**Comments on the additional submission for Planning Application-
6/2018/2768/OUTLINE to build 1100 homes in Ellenbrook Fields,
by Cllr Margaret Eames-Petersen
(Hertfordshire County Councillor for Hatfield North Division)**

Objection

These comments are directed at the addenda that have been added to the Environmental Impact Assessment submitted by Arlington on the following:

Fig 2

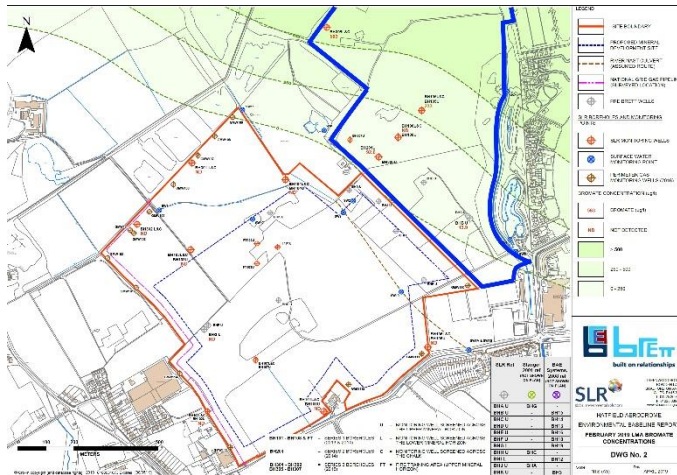
The latest plume drawing from Hatfield Quarry Application, shows bromate over 500µg/l (green) in the North where the planned housing would be:

This map was produced for the quarry application and shows the bromate contours under the housing site (dark green). The blue line shows the southern part of the housing application.

Fig 3

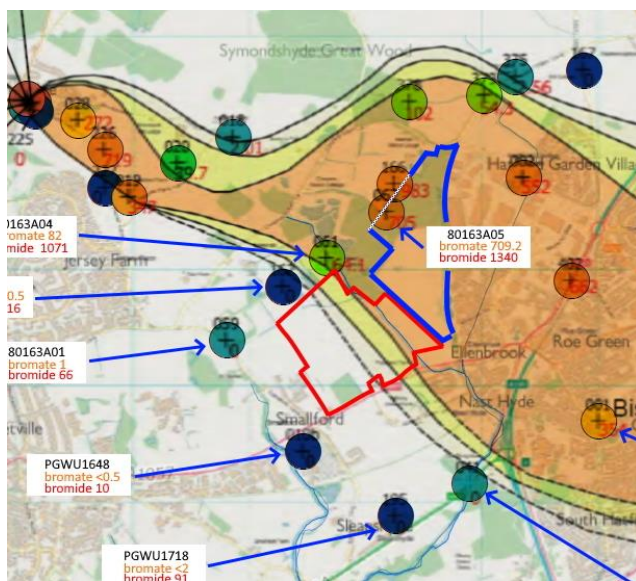
- that there is no mention of “adjacent/overlapping sites” such as the proposed Brett quarry to the East. Attenuation lakes practically touch Infiltration lagoons in the South at this specific area, this would constitute a high risk for cross-contamination ...see fig 3.

EA plume drawing showing boreholes and housing applicant site. Borehole 80163A05 @ 709.2µg/l bromate is to the West of the housing site.

The EA map is expanded from Part 2A of Environmental Protection Act 1990 St Leonards Court document showing greater than 50µg/l bromate in light red. The site is in the middle of the plume. To the South is the Brett quarry application in red outline.

Fig 4

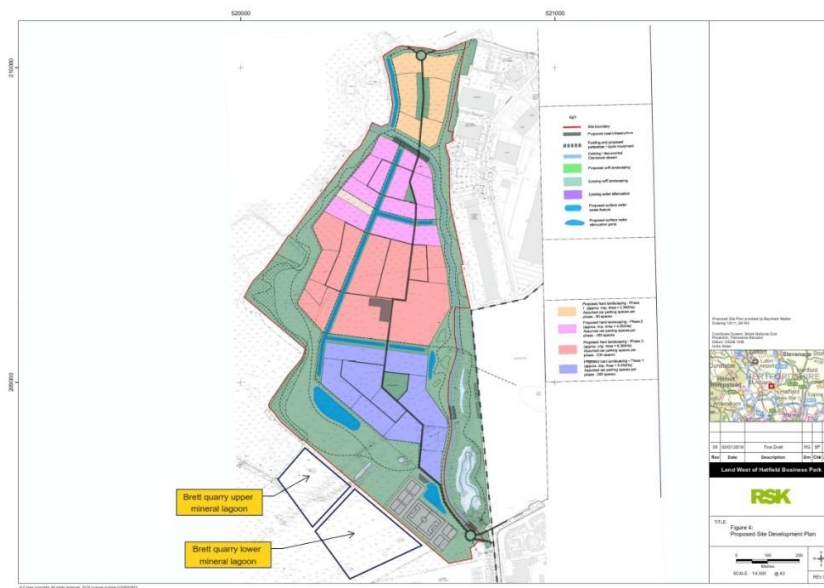
- The cumulative effect of attenuation lakes in the South and Brett quarry infiltration lagoons in the same area was not taken into consideration Fig 4.

Fig 4. shows proposed Brett quarry lagoons in the South. The expected infiltration rate of the Upper Mineral Horizon is estimated at 1,100 to 2,300 cubic metres/day directly into the same ground that the attenuations ponds (blue) would add another 1000 to 2500 cubic metres/day, from the run off from the new development. These totals double the groundwater amount, which is now focused on a specific area potentially leading to flooding downstream of the combined sites.

Fig 5

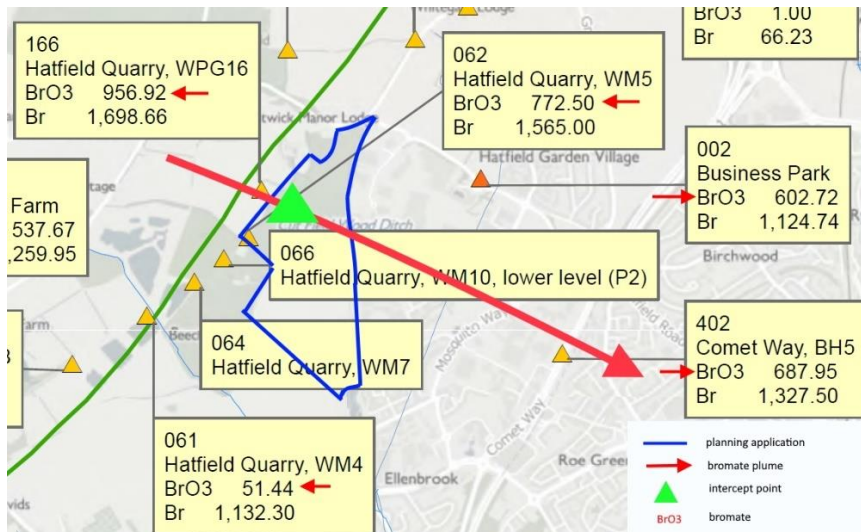
- The objection is that the EA remedial plan using an array of boreholes, perpendicular to the plume and at its highest bromate levels, would require an area to operate that is clear of obstacles and housing.

The intercept point is shown in green. The plume has a S.E direction.
